CR-Form-v5
CHANGE REQUEST
⌘ 33.200 CR ⌘ rev - ⌘ Current version: 5.1.0 ⌘

Title:	⌘ Correcting the network behaviour in response to an incorrect AUT-S		
Source:	⌘ Hutchison 3G UK		
Work item code:	⌘	Date:	⌘ 7/5/02
Category:	⌘ F	Release:	⌘ Rel-5
	Use <u>one</u> of the following categories: F (correction) A (corresponds to a correction in an earlier release) B (addition of feature), C (functional modification of feature) D (editorial modification) Detailed explanations of the above categories can be found in 3GPP TR 21.900 .		Use <u>one</u> of the following releases: 2 (GSM Phase 2) R96 (Release 1996) R97 (Release 1997) R98 (Release 1998) R99 (Release 1999) REL-4 (Release 4) REL-5 (Release 5)

6.1.3 Synchronization failure

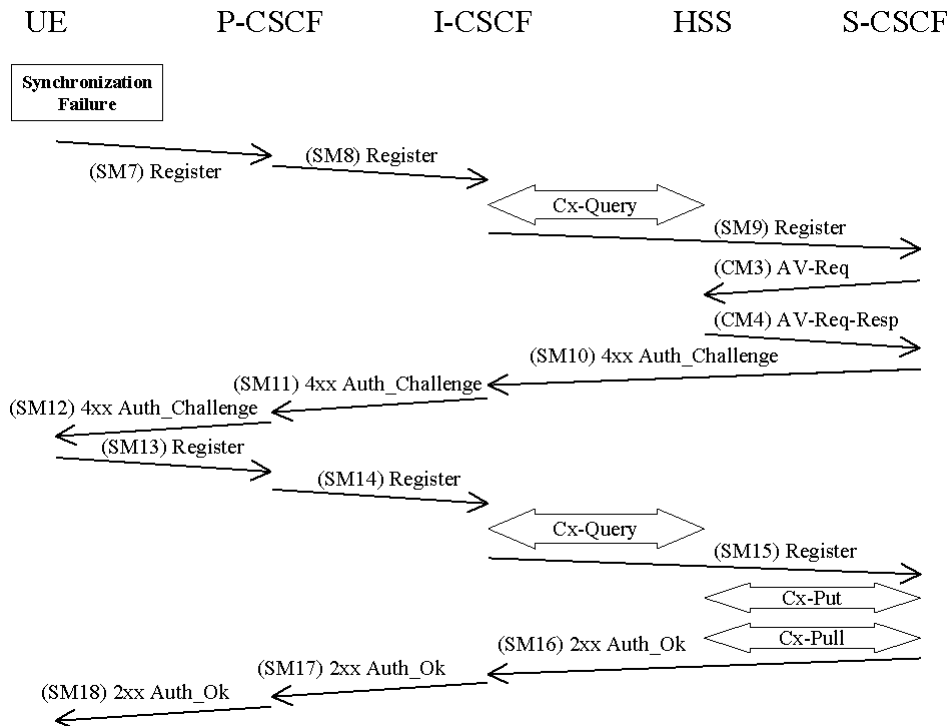
Reason for change:	⌘ Currently the text states the behaviour should follow the behaviour in TS 33.102. It also makes returning AVs conditional on a successful checking of AUTS. This is out of line with TS 33.102 which returns AVs regardless of whether AUTS was successful or not. The change is to make the behaviour describe inline with TS 33.102
Summary of change:	⌘ To make the HSS always return AVs whether the AUTS check is successful or not.
Consequences if not approved:	⌘ Inconsistency in the specification that could lead to incompatible implementations.

The HSS checks the AUTS as in section 6.3.5 in [1]. ~~If the check is successful and~~ After potentially ~~after~~ updating the SQN, the HSS ~~creates and~~ sends new AVs to the S-CSCF in CM4.
